Grand Prix GP-10C 2-Post Lift: Hydraulic Port Tee Fitting

BendPak TSB 189-102025

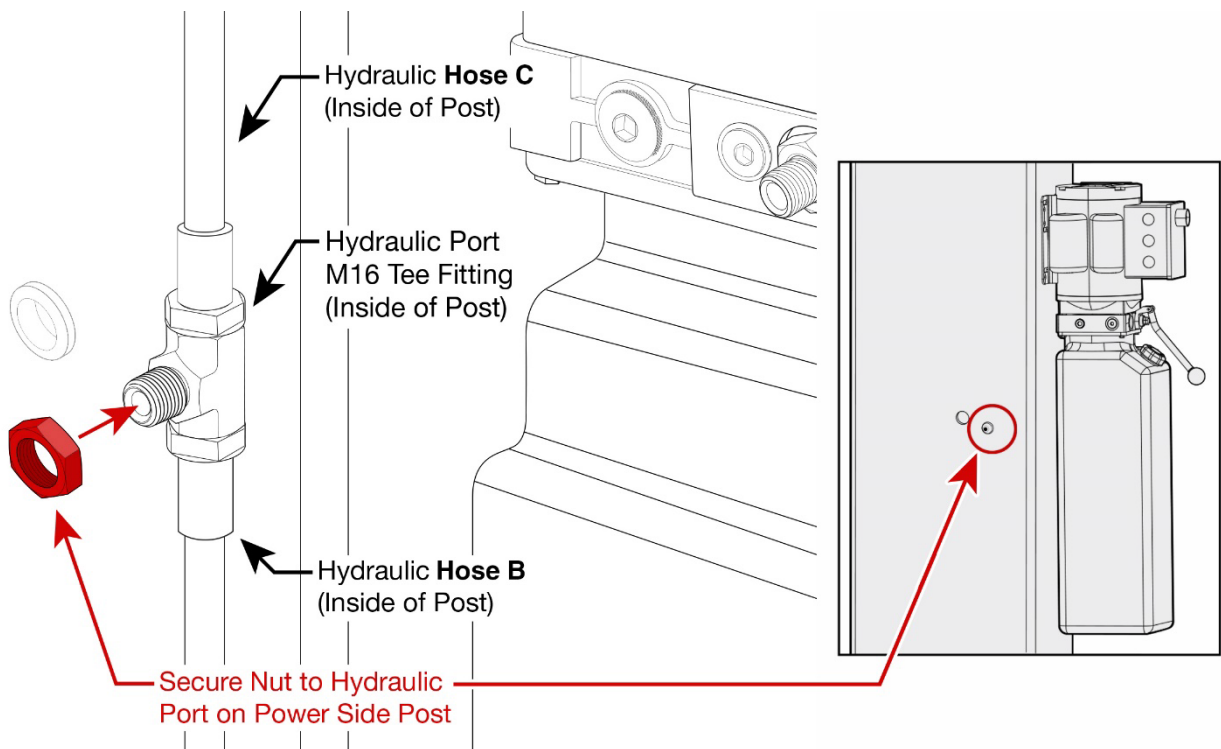
This Technical Service Bulletin intends to clarify the installation of the Hydraulic Port (M16 Tee Fitting) to the Power Side Post on the Grand Prix GP-10C 2-Post Lift. The installation is as follows:

1. Remove the dust cap and then the Nut from the M16 Tee Fitting on the **inside** of the Power Side Post.
2. Ensure that Hose **C** and Hose **B** are securely tightened to the M16 Tee Fitting.
3. From the **inside** of the Power Side Post, press the open male end of the M16 Tee Fitting out through the opening in the Post. The fitting (Hydraulic Port) should now be visible from the **outside** of the Post.
4. From the **outside** of the Post, fully tighten the previously removed Nut to the M16 Tee Fitting, securing the fitting (Hydraulic Port) to the Post as shown in the illustration below.
